## AIRWORTHINESS DIRECTIVE

### Cessna 170, 172, F172, FR172 & 175 Series Aeroplanes

**AD/CESSNA 170/57  
Amdt 4**

**Forward Door Post Bulkhead**

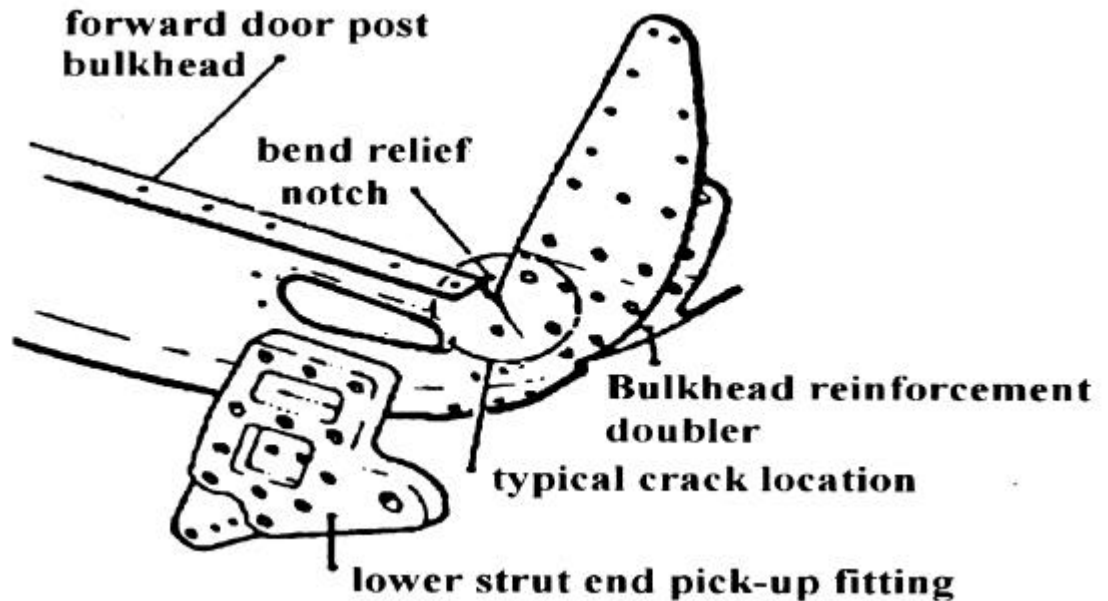
1. Visually inspect the wing strut lower attachment structure to determine the type of strut attachment used. Aircraft with the earlier embedded type strut attachment are not subject to any further action. Aircraft with strut attachment fittings of the type with the protruding lug, similar to that shown in the diagram below, must comply with Requirement paragraphs 2 and 3.

2. Visually inspect for cracks at the inside edge of the left hand and right hand bend relief notches of the forward door post bulkhead.
3. Visually inspect for loose or working fasteners securing the lower strut end pick-up fitting to the forward door post bulkhead. The inspection areas and typical crack location are shown in the diagram below.
